CITY OF
SURREY
ENGINEERING DEPARTMENT

CONTRACT NUMBER:	6021-004-11
CONTRACT TITLE:	COLEBROOK PUMP STATION REPLACEMENT
ADDENDUM NUMBER.:	2
ADDENDUM ISSUE DATE:	2022-10-19

COLEBROOK DRAINAGE P.S. REPLACEMENT
MECHANICAL
LAYOUT AND SPECIFICATIONS

SCALE: AS SHOWN
DATE (YYYY.MM.DD) 2022.05.04
CONSULTANT PROJ. NO. 1072.0292.01
DESIGNED BF
DRAWN BF
REVIEWED TW
DWG. NO. E01
REV. 4
SURREY PROJECT NUMBER **6021-0004**
SURREY DRAWING NUMBER

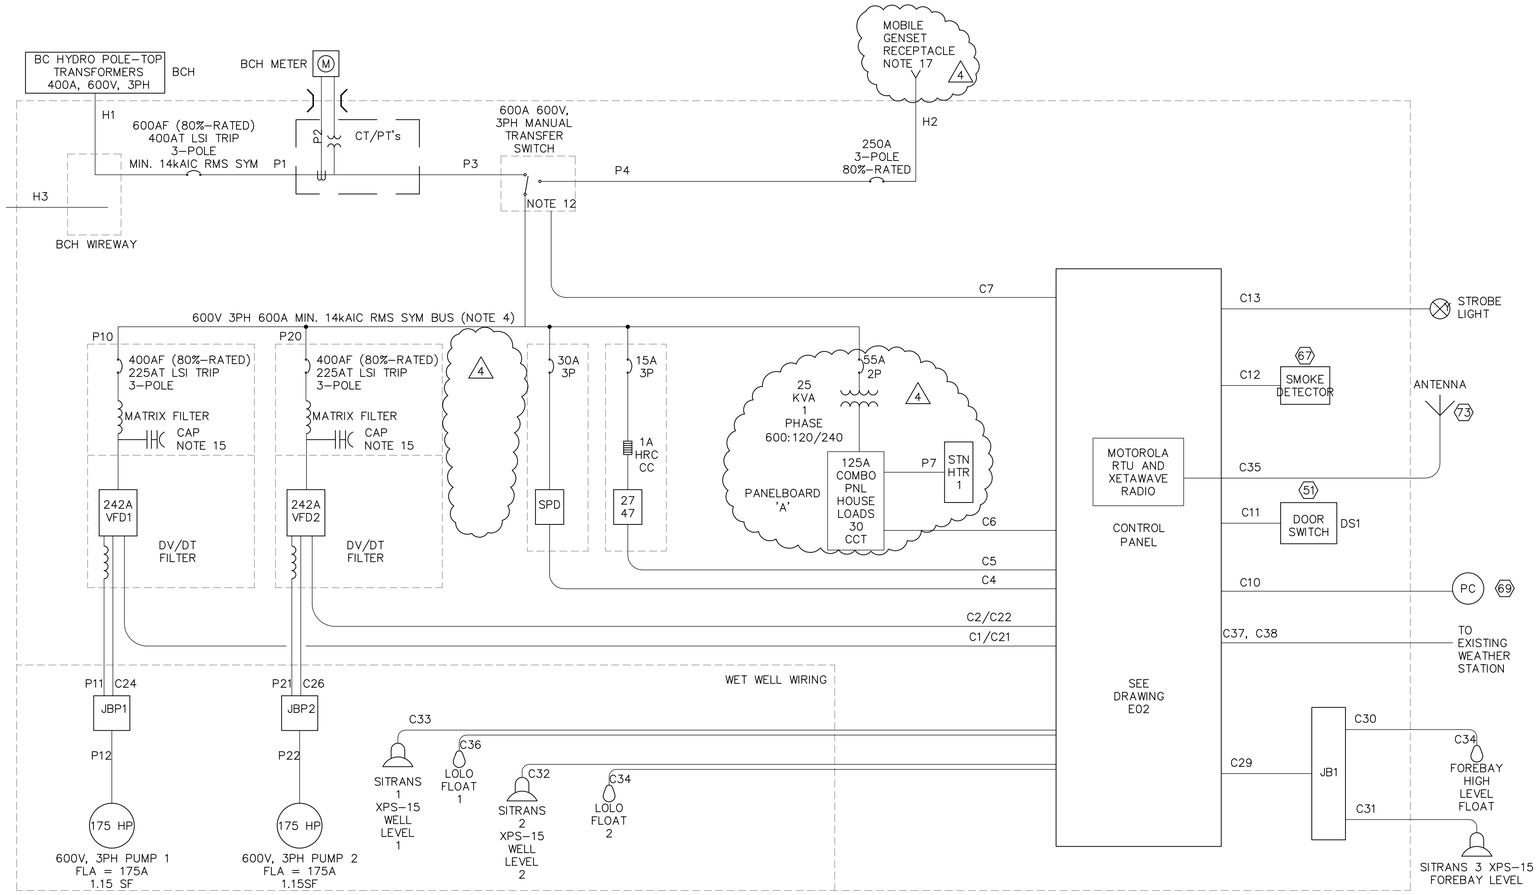
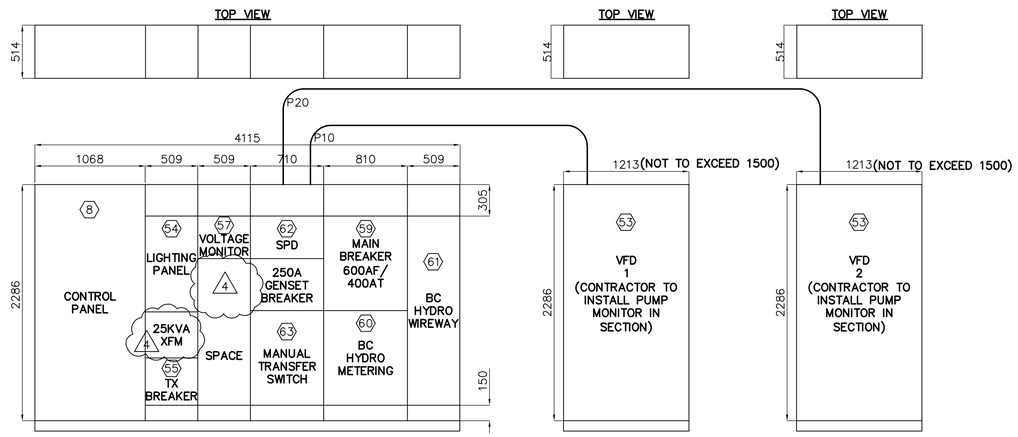
Q11: Are there specifications for the genset receptacle?

A11: Refer Revision 4 of E01 included with this addendum.

17. THE GENERATOR RECEPTACLE IS 400A, 4 POLE (4 WIRE + BOND) WITH MALE PINS (REVERSE-PINNED, OPTION S22), ROTATED INTERIOR (SPECIAL POLARITY, OPTION S4) & SPRING DOOR. CROUSE-HINDS "ARKTITE" SERIES, CAT. #AREX40418 C/W 'AJ' BACKBOX & ANGLE ADAPTER.

AN ENGRAVED STAINLESS STEEL NAMEPLATE SHALL BE INSTALLED ON THE BUILDING EXTERIOR DIRECTLY ABOVE THE RECEPTACLE AND SHALL READ AS FOLLOWS: "GENERATOR RECEPTACLE – 347/600 VAC, 3 PHASE, 4 WIRE + BOND, 250A MAXIMUM".

OUTDOOR WALL LIGHTS CONTROLS

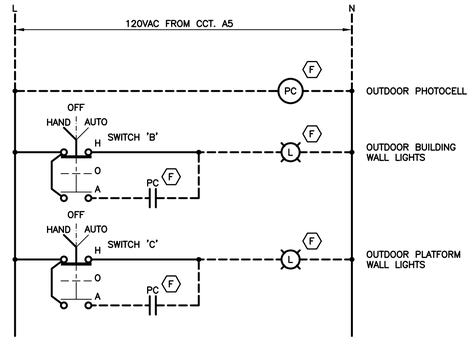
Q10: Is the integral photocell specified in the type A luminaires going to interfere with the exterior lighting control system specified on page E04

A10: Refer to revised specifications. The Photocell requirement has been removed from the Type A luminaire.

DWG. NO. **E09**

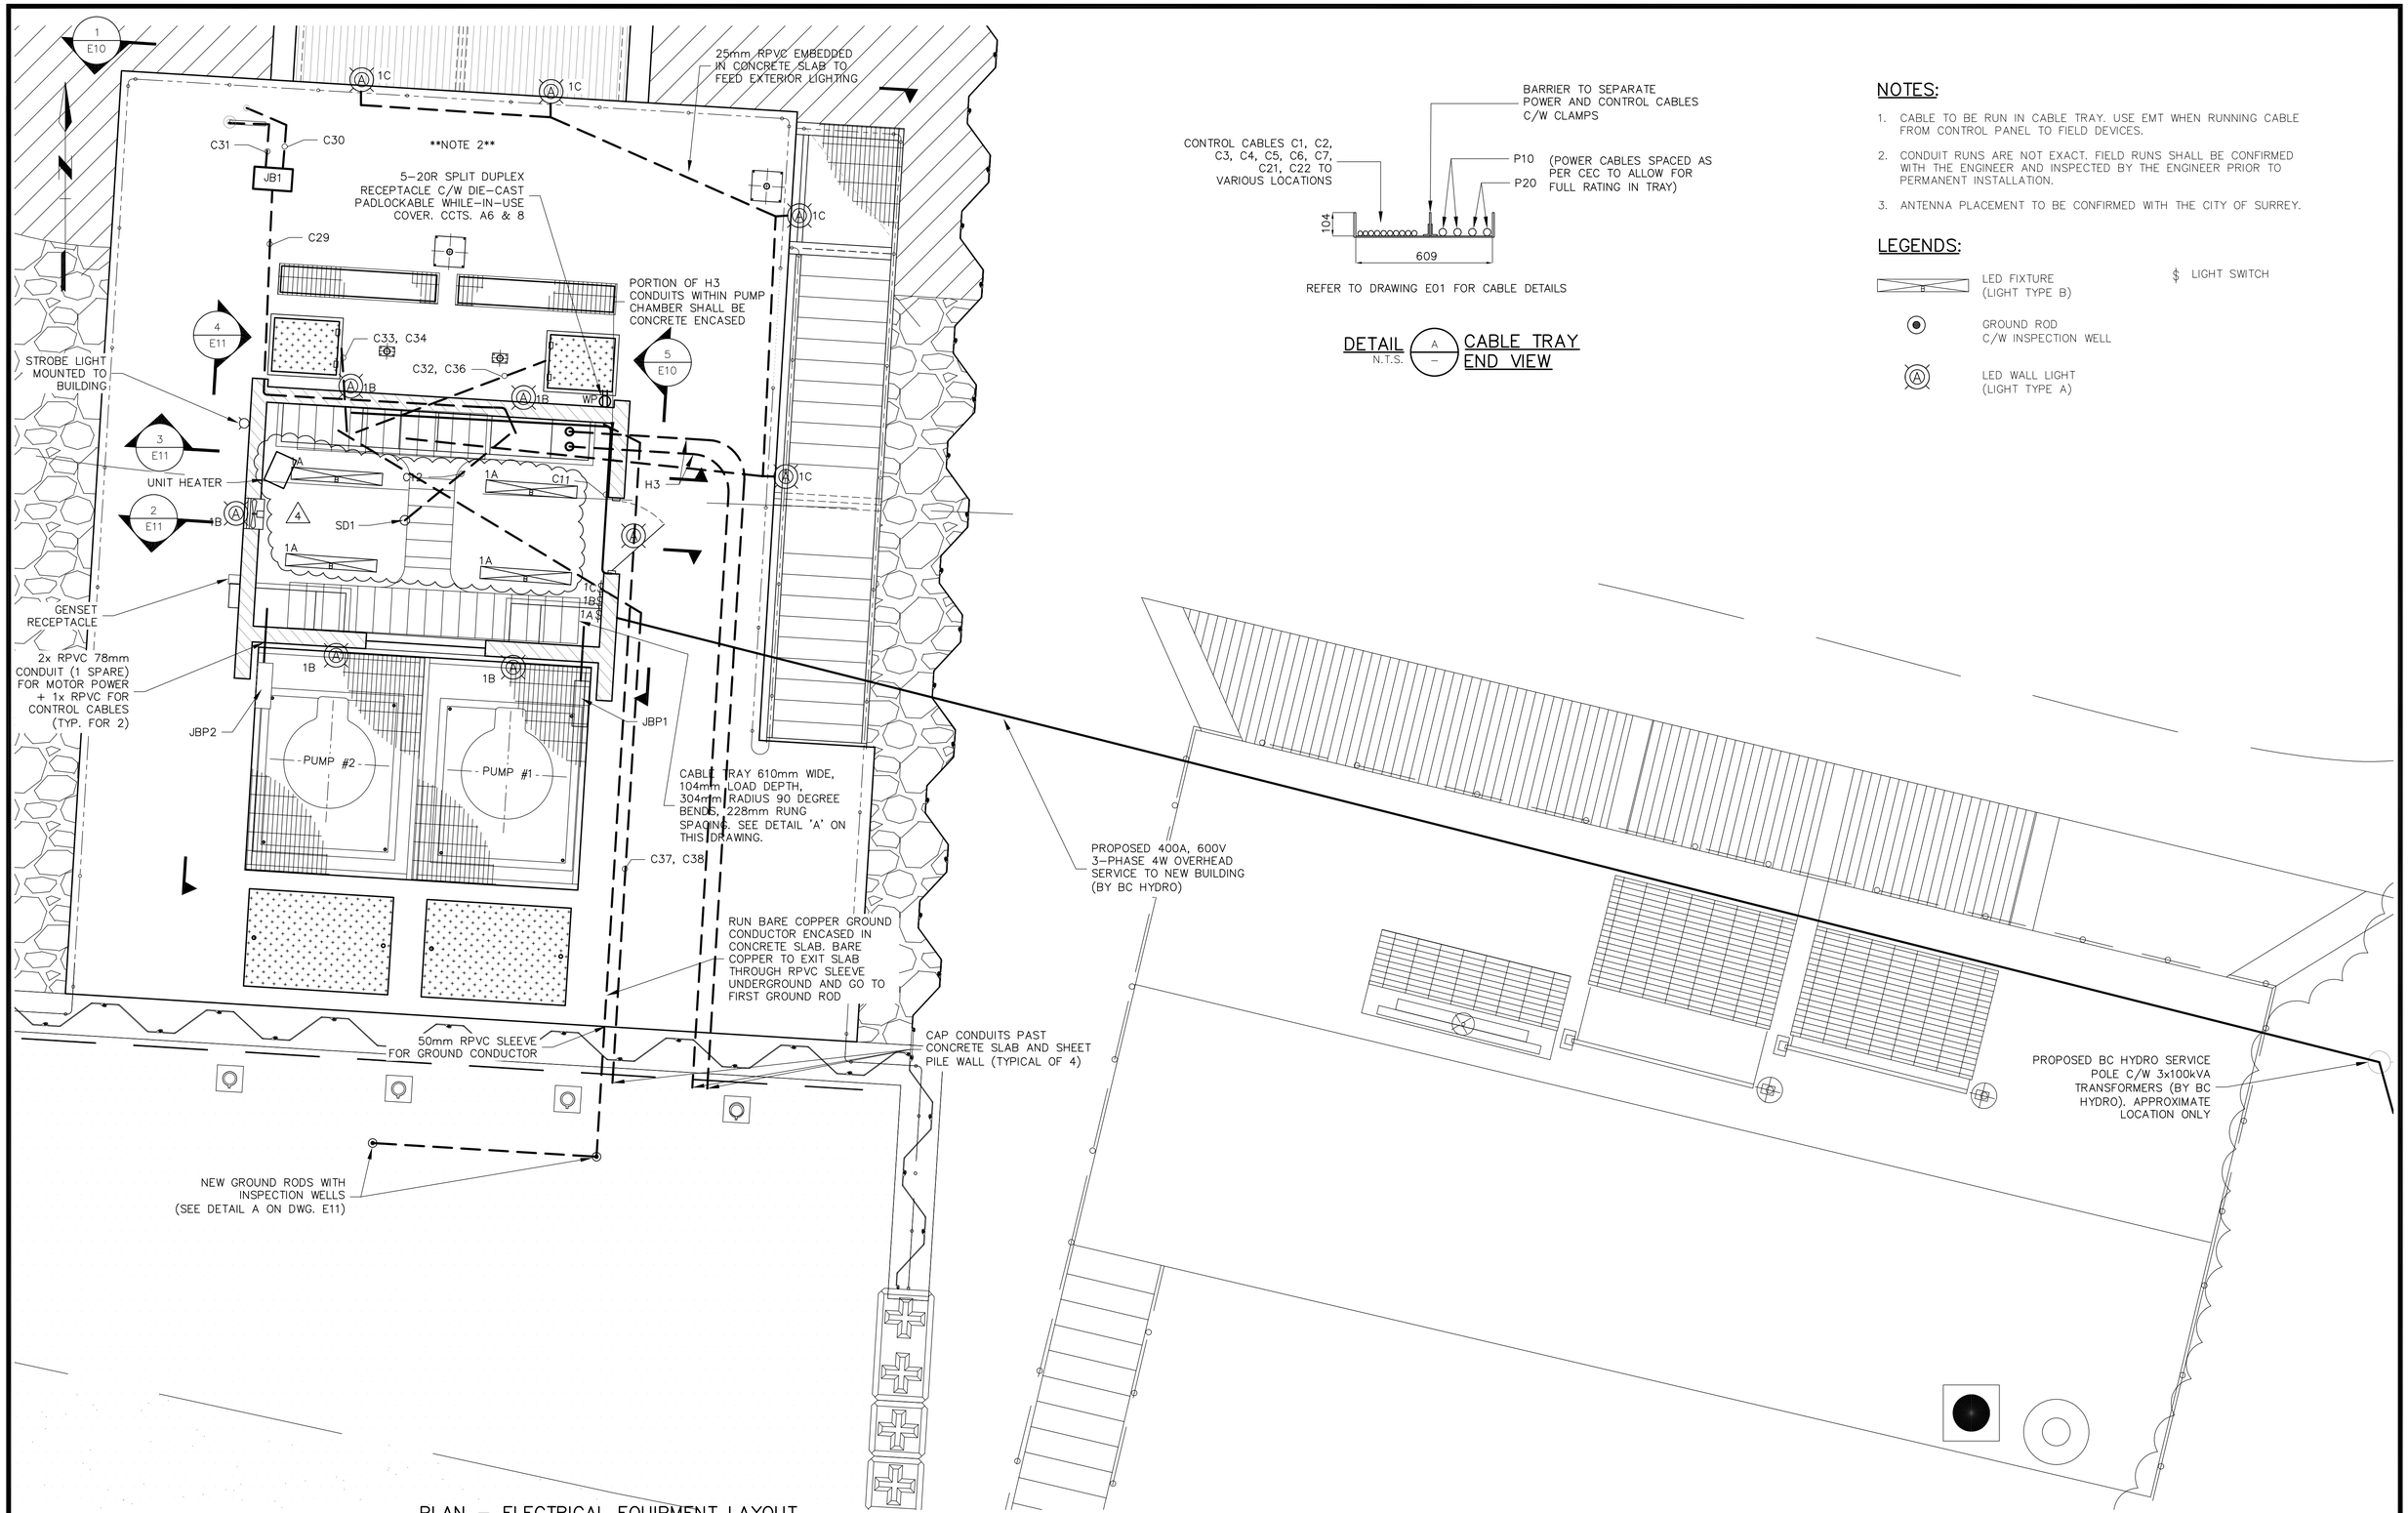
Q7: Lighting specification 26 50 00 shows type C fixture, this is not shown on the drawings. Please confirm if fixture Type C is required.

A7: the Type ‘C’ fixture is shown on drawing E11 as ‘150W LED Floodlight’ and is mounted to the SCADA antenna mast.
